CITY OF LEWISTON
PLANNING BOARD MEETING
Monday, July 14, 2014 – 5:30 P.M.
City Council Chambers – First Floor
Lewiston City Building
27 Pine Street, Lewiston

TO: Planning Board
FROM: David Hediger, City Planner
DATE: July 10, 2014
RE: July 14, 2014 Planning Board Agenda Item IV(a)

An application submitted by Platz Associates on behalf of the Greater Androscoggin Humane Society to construct a new facility at 56 Strawberry Avenue.

TO: Platz Associates
FROM: David Hediger, City Planner
DATE: July 7, 2014
RE: Human Society, 56 Strawberry Ave

DRAWING C-2

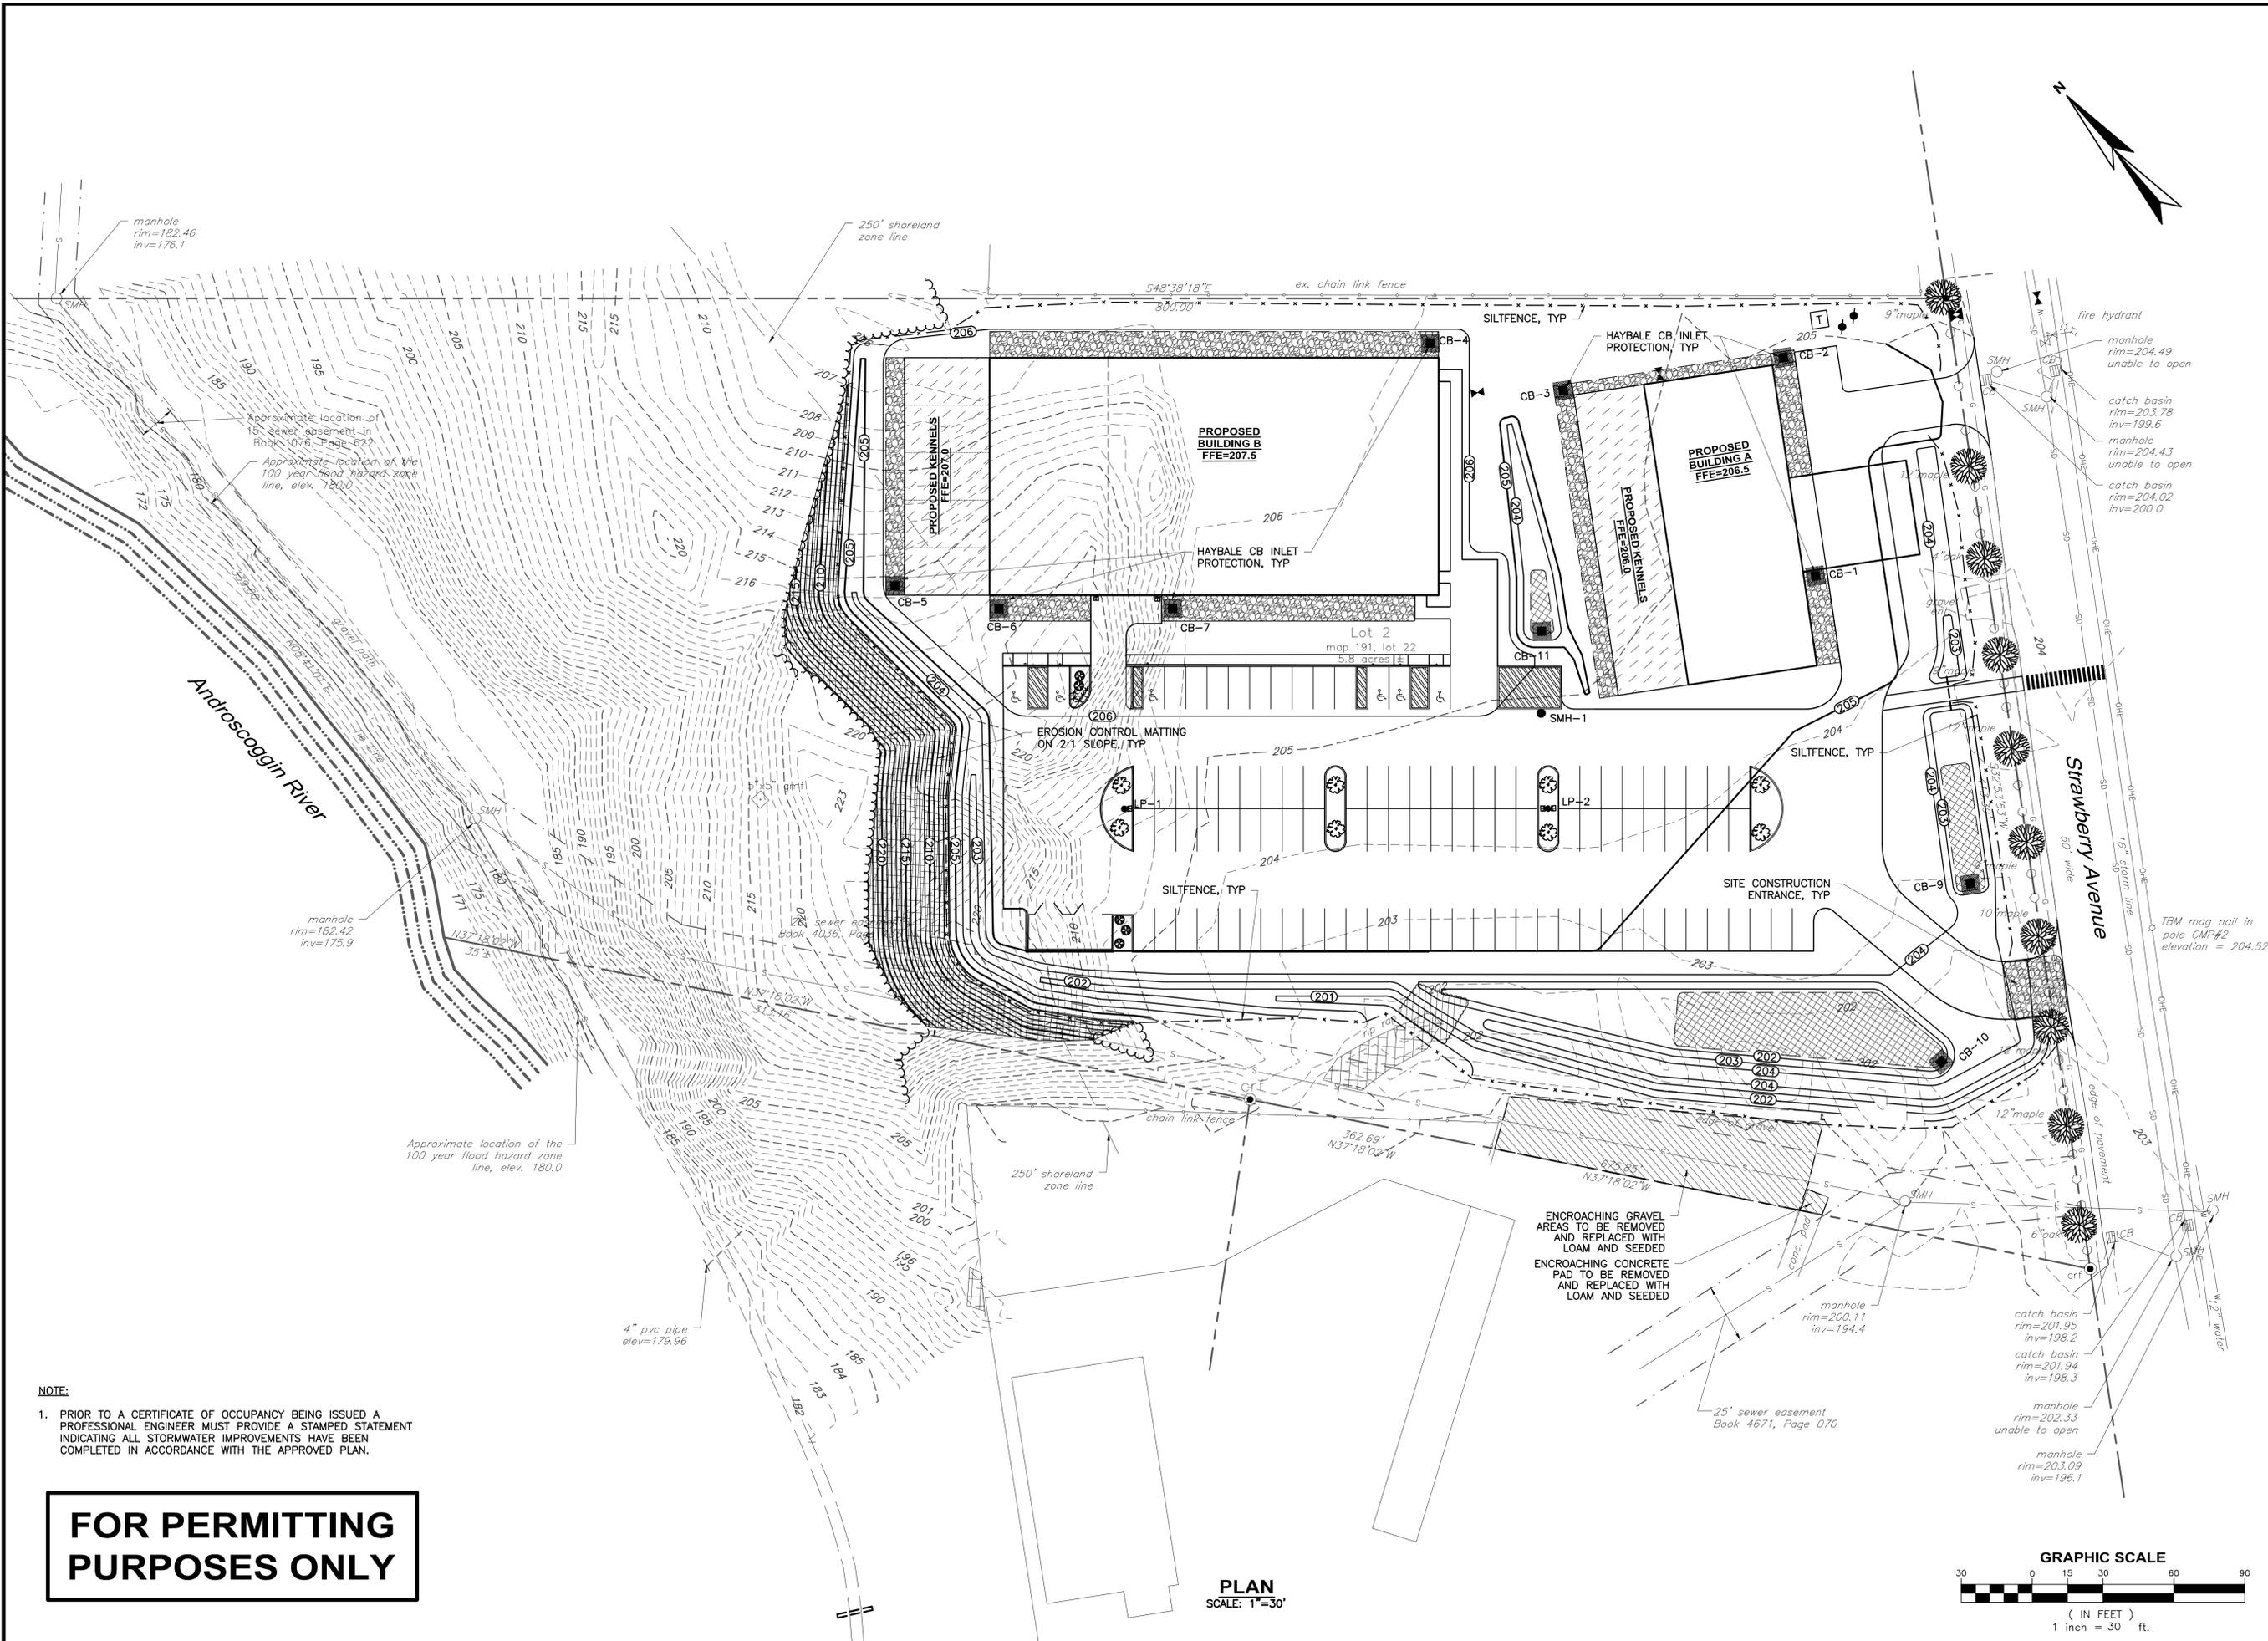
8. Drawing C-2 – The water services to the two buildings shall be separated inside the City Right of Way with a separate shut off for each. If a 6” Fire line is added for either building it will require the shut off to be located within the city Right of Way as well.

9. Sheet C-2 – All connections to city Manholes and Catchbasins shall be cored and booted connections.
10. Sheet C-3 – Silt fence is shown up gradient of construction in some areas, this may cause ponding of water on adjacent parcels and should be evaluated for need.
